M O D E L: "220"

SERIES: "DA" **TYPE: 2 UNIT AUTO**

6 Tube, Auto, Superheterodyne,
Broadcast Receiver (2 unit)

CHANGE NOTICE INDEX.

Bottom view of base.

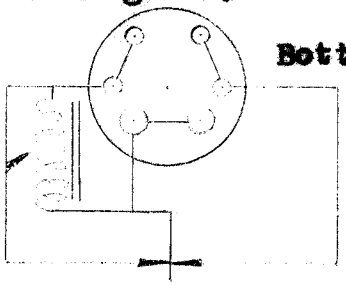
Connections to base as per diagram.
